Peer Review Panel

Report on Findings

Review of Three Operations Studies for the Design of the Caltrain Downtown Extension (DTX)

for: San Francisco County Transportation Authority (SFCTA)

Figure 1

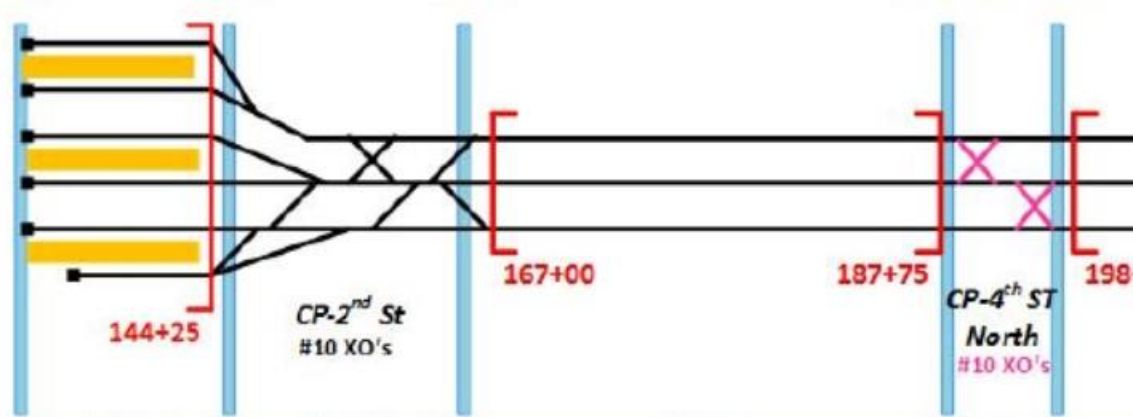
The peer review panel recognizes that the track alignment reflected in the Parsons study (Figure 1), including switch locations, has been reviewed and agreed to by Caltrain and CHSRA and has been signed off by FRA. This alignment is understood to reflect the current operational thinking of CHSRA and Caltrain, and considers the ventilation zones established for fire safety.

It is also understood that the alignment is a Preliminary Engineering concept (15% design), so adjustments can be expected as the plans are finalized to reflect operating plans and the resolution of the dedicated platforms question. At this stage in project development, the peer review panel recommends that the configuration of switches and crossovers at the throat of the STC be finally established based on the resolution of these parameters.

The two diagrams are clearly very different. Access to and from the low numbered station tracks is improved in the approved Parsons layout.

Figure 2

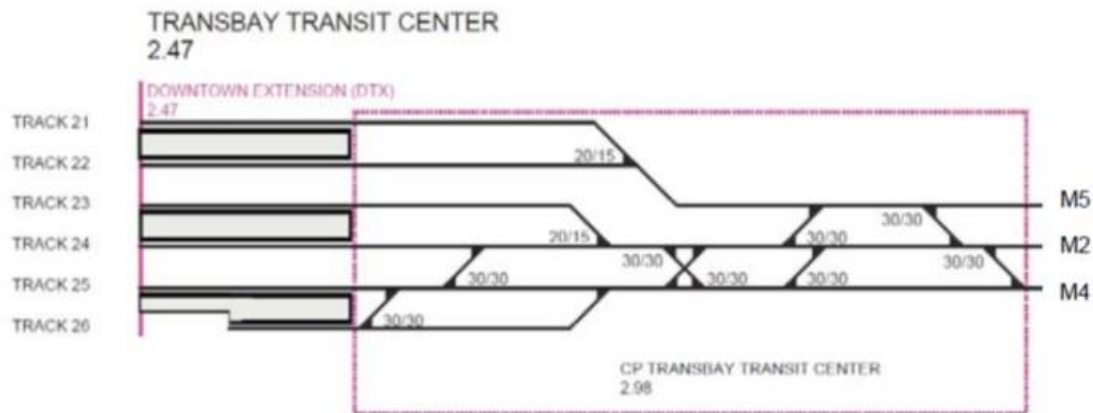
Figure 2 shows the base track configuration of the throat of the STC as depicted by the RAB report team in the Spring of 2017. It calls for one interlocking and seems to support high turnover on station tracks 24, 25 and 26. Tracks 21 and 22 appear to be designed for a much lower level of traffic with movements to or from either track blocking access to the other.
